Model: General RTB	Date: 4-Feb-03	No.: RGene013b
--------------------	----------------	----------------

Subject: Service remarks at installation		Prepared by: T. Itoh	
From: Technical Service Sec. Service Planning Dept.			
Classification:	<input type="checkbox"/> Troubleshooting	<input type="checkbox"/> Part information	<input type="checkbox"/> Action required
	<input type="checkbox"/> Mechanical	<input type="checkbox"/> Electrical	<input type="checkbox"/> Service manual revision
	<input type="checkbox"/> Paper path	<input type="checkbox"/> Transmit/receive	<input type="checkbox"/> Retrofit information
	<input checked="" type="checkbox"/> Other (Specification change)

Model: Model J-P2		Date: 2-Apr-03	No.: RG080001
Subject: Service Manual Revision		Prepared by: H.Taguchi	
From: 1st Tech. Support Sec. Service Support Dept.			
Classification:	<input type="checkbox"/> Troubleshooting	<input type="checkbox"/> Part information	<input type="checkbox"/> Action required
	<input type="checkbox"/> Mechanical	<input type="checkbox"/> Electrical	<input checked="" type="checkbox"/> Service manual revision
	<input type="checkbox"/> Paper path	<input type="checkbox"/> Transmit/receive	<input typ

Page 1-7

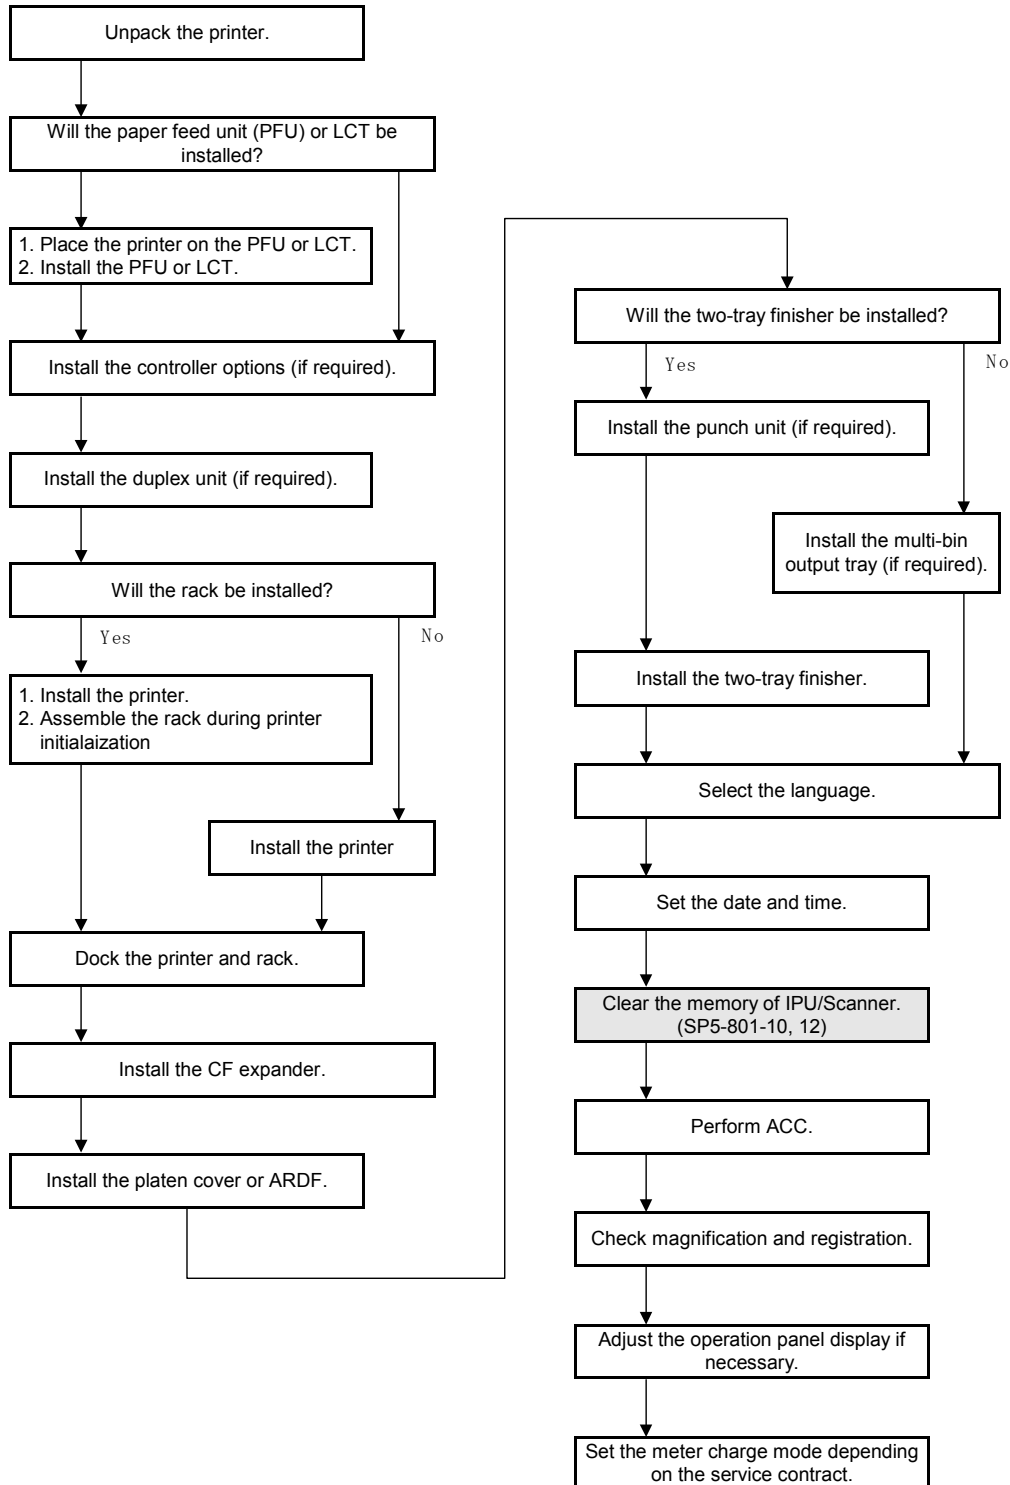
Contents revised: The following bold word was deleted from the flowchart illustration.

Clear the memory of IPU/**Netfile**/Scanner (SP-5-801-10,12) ].

**Page 1-32**

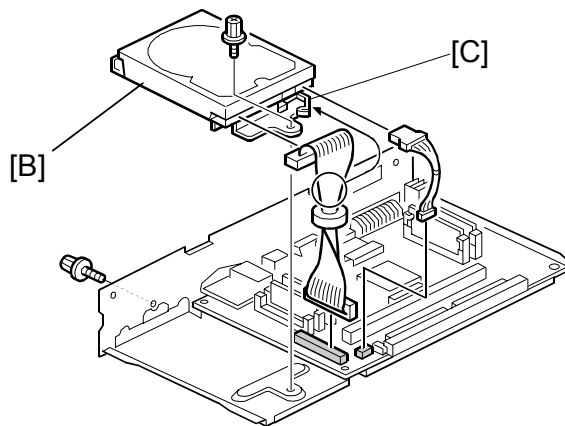
A harness clamp [C] and harness core have been added, and the harness attachment has been revised as follows.

2. Mount the 40GB HDD [B] on the controller (Harness x 2, Screw x 2, **Clamp[C] x 1**)

Page 3-10

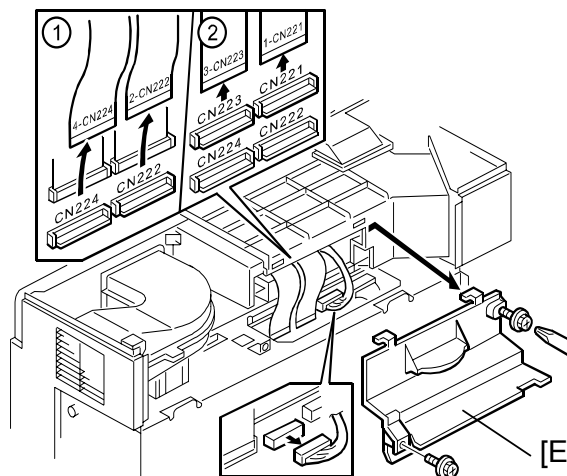
- A screw has been added and the shape of the connector cover has been changed as follows.

12. Connector cover [E] (Screw x 2)

Page 3-23

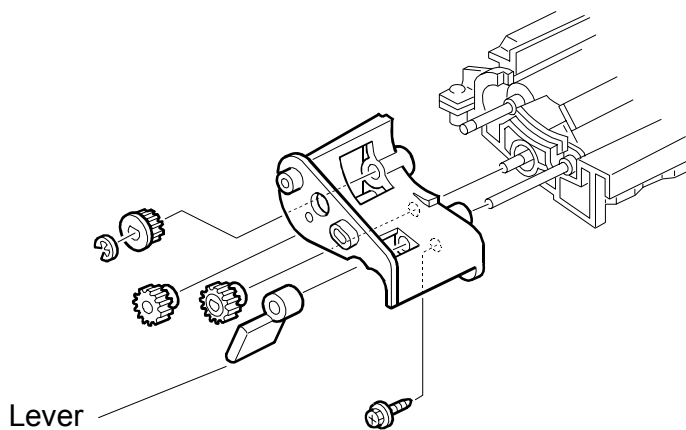
- The screw which stops the lever has been deleted, and the shape of the lever has been changed as follows.

- Step 4 deleted.

4. Lever [C] (Screw x 1)

Page 3-25

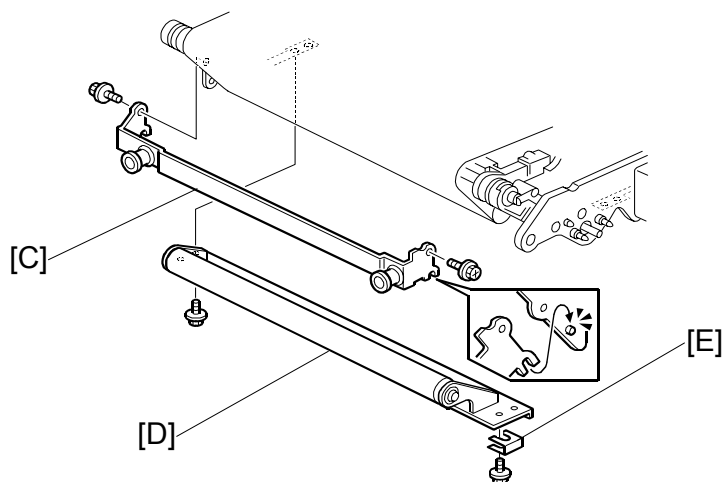
- A spacer [E] has been added.

6. Tension roller [D] (**Spacer [E] x 1**, Screw x 2)

Page 3-42

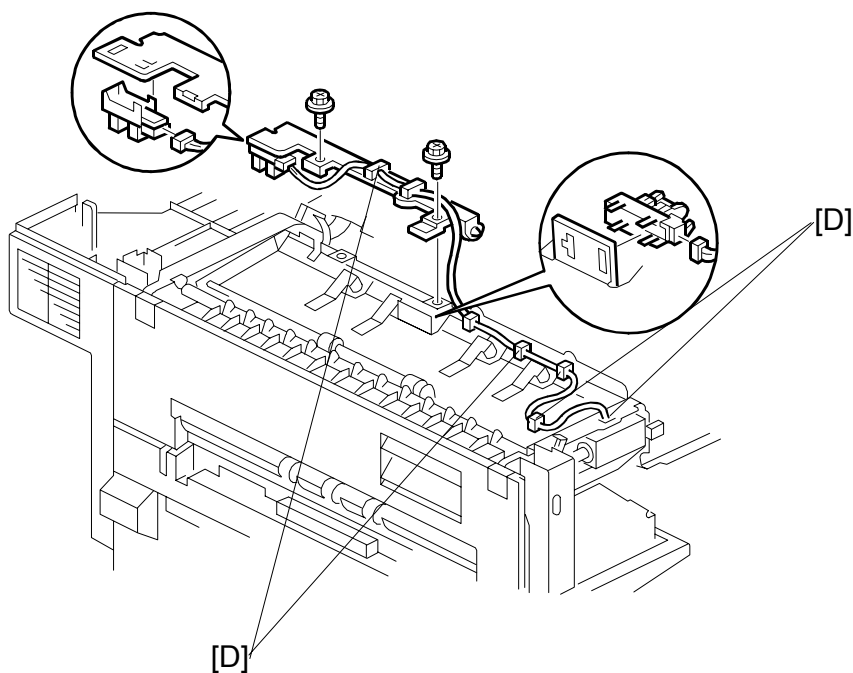
- Four clamps [D] have been added, and the attachment of the harness has been changed as follows. The clamp at the right-hand end is not visible in the drawing.

**Page 3-43**

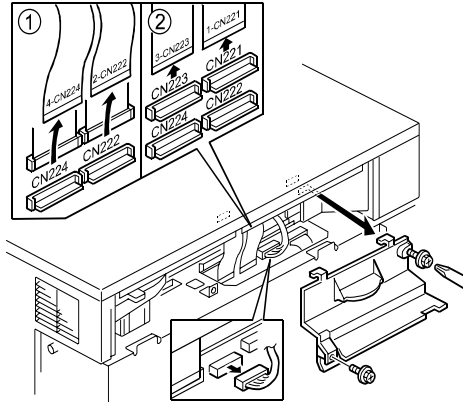
- A screw has been added, and the shape of the connector cover has been changed as follows.

4. Connector cover [E] (Screw x 2)

**Page 3-45**

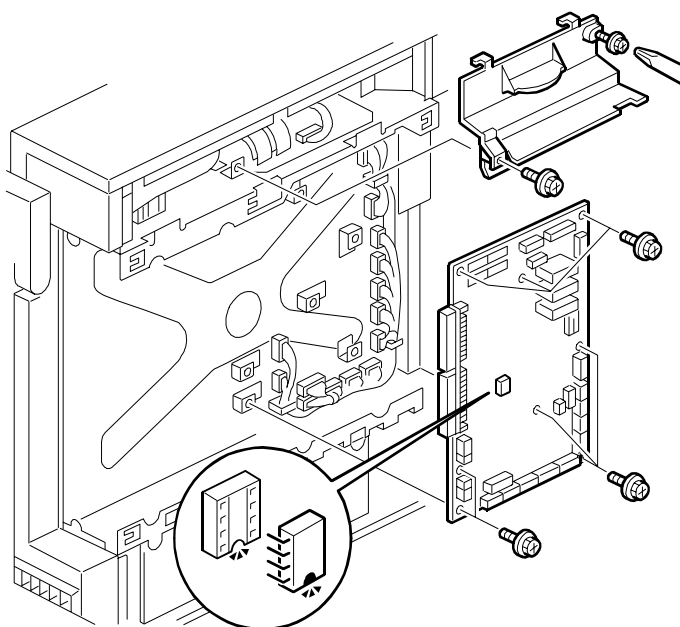
- A screw has been added and the shape of the connector cover has been changed as follows.

6. Connector cover [E] (Screw x 2)

## Page 3-50

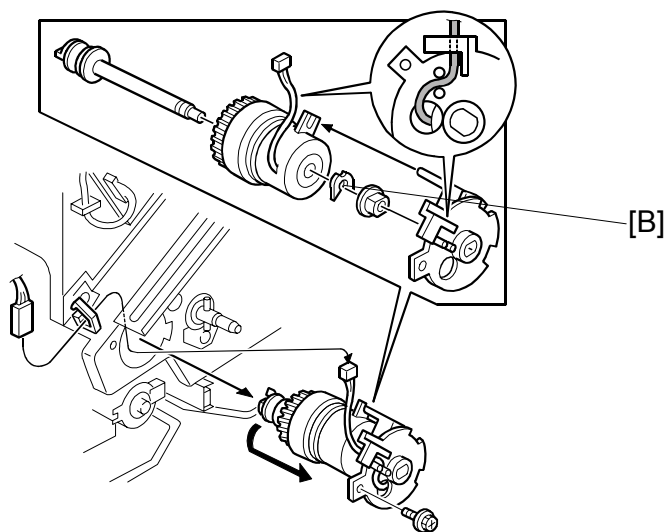
- A retaining ring [B] has been inserted between the magnetic clutch and the bushing, as follows.

3. Development clutch [A] (Connector x 1, Screw x 1, **Retaining ring [B] x 1**)

**Page 6-42**

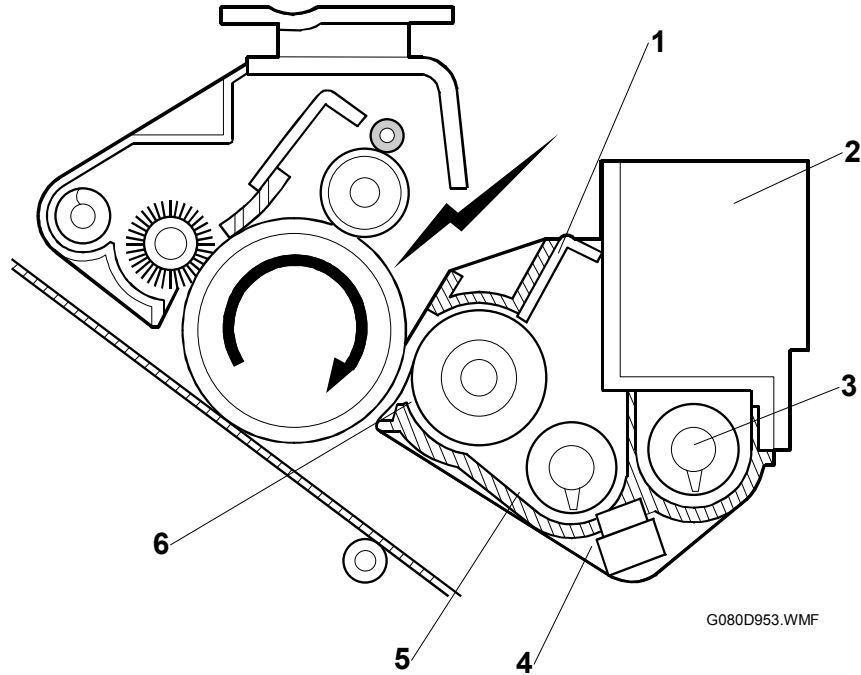
- Illustration revised to show correct parts:

Page 1-29

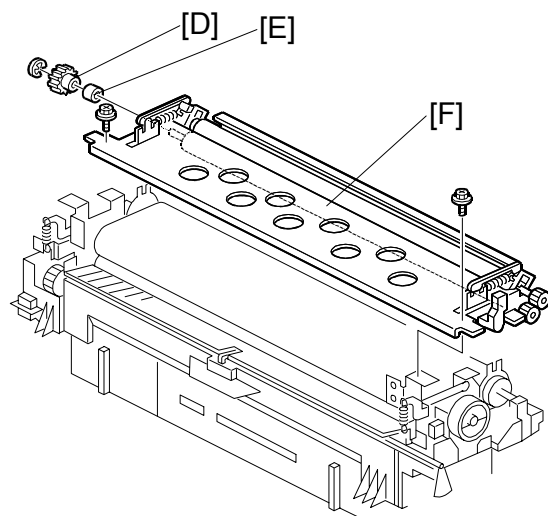
- Between Steps 16 and 17:

- **Attach the cloth holder [F] to the left face of the scanner unit.**
- **Place the contact glass cleaning cloth [G] in the cloth holder [F].**
